MONTICELLO NUCLEAR GENERATING PLANT
Docket No. 50-263 License No. DPR-22

Response to 2/4/76 Questions on MSL Setpoints and MCPR

SCRAM REACTIVITY FOR MONTICELLO CYCLE 5

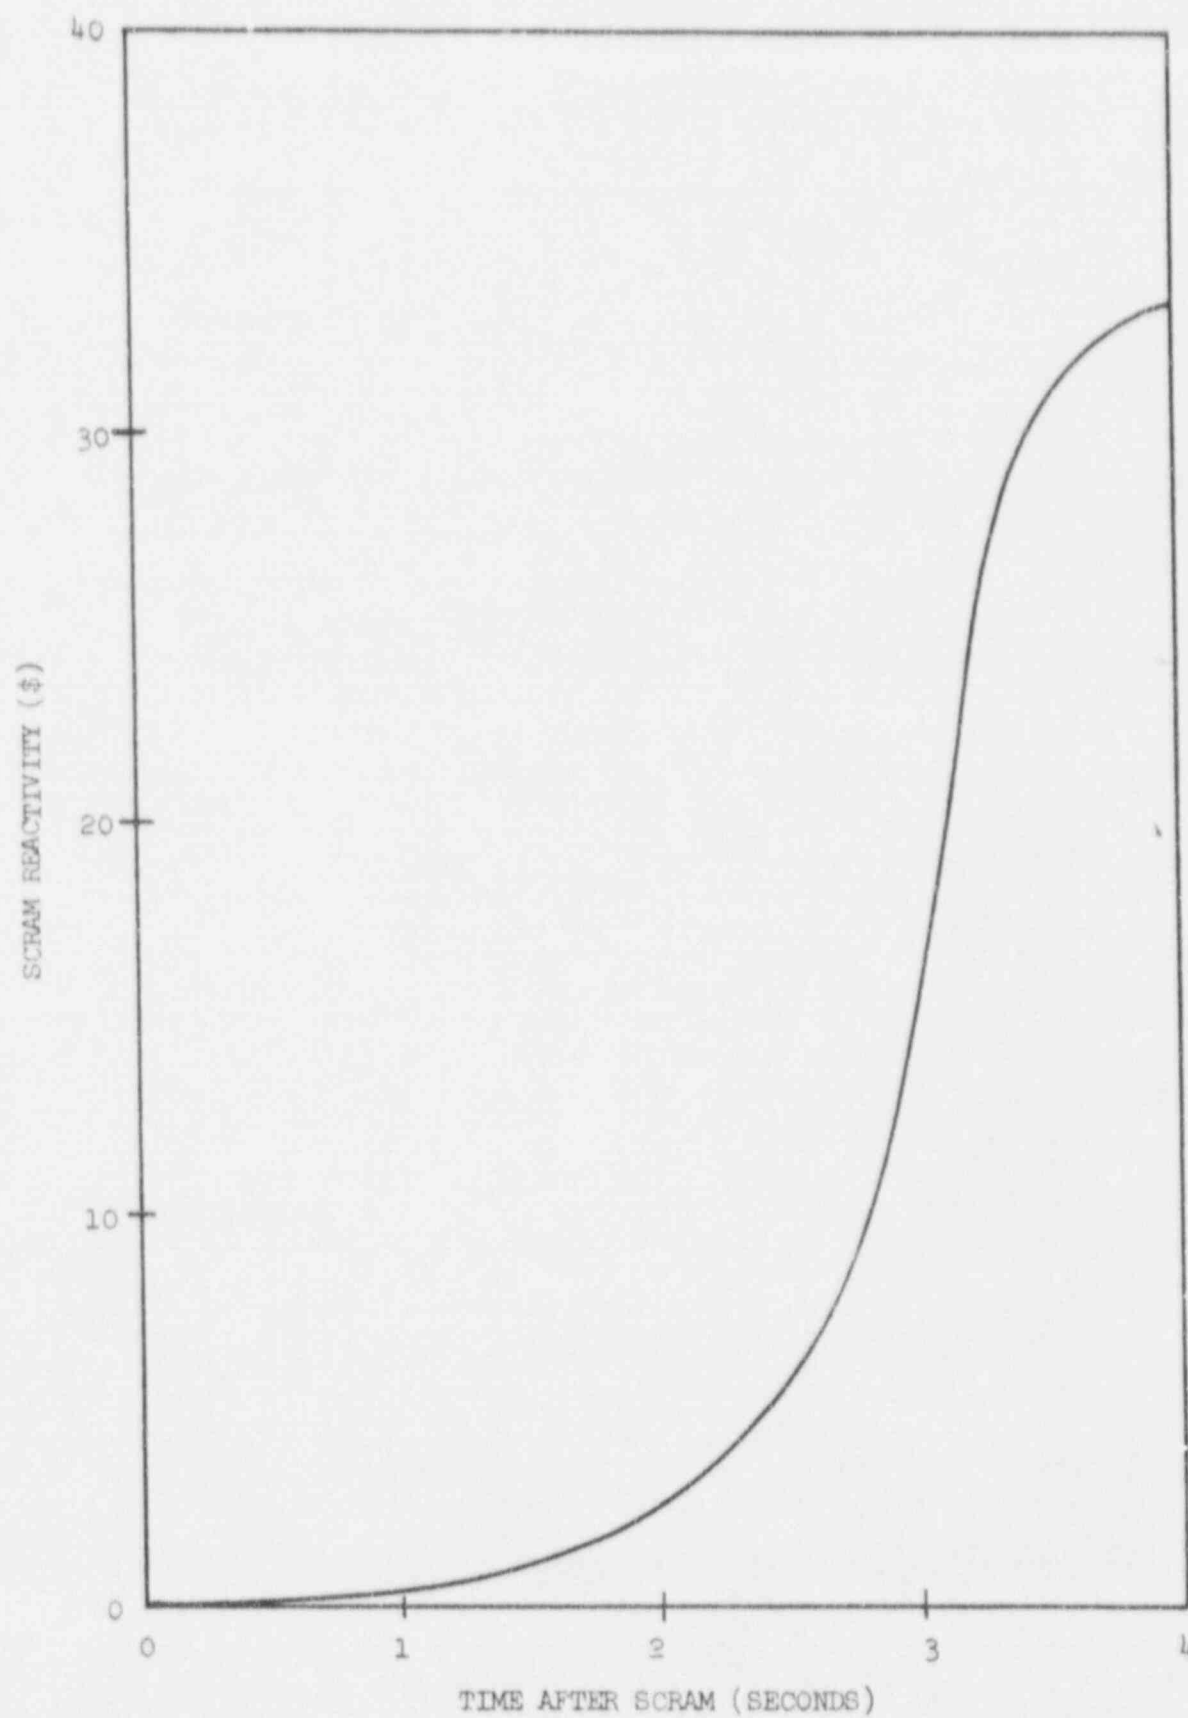
Provide the scram reactivity curve for EOC5.

The attached figure shows the scram reactivity used in the Cycle 5 analyses. This is conservatively derated to 80% of the expected value.
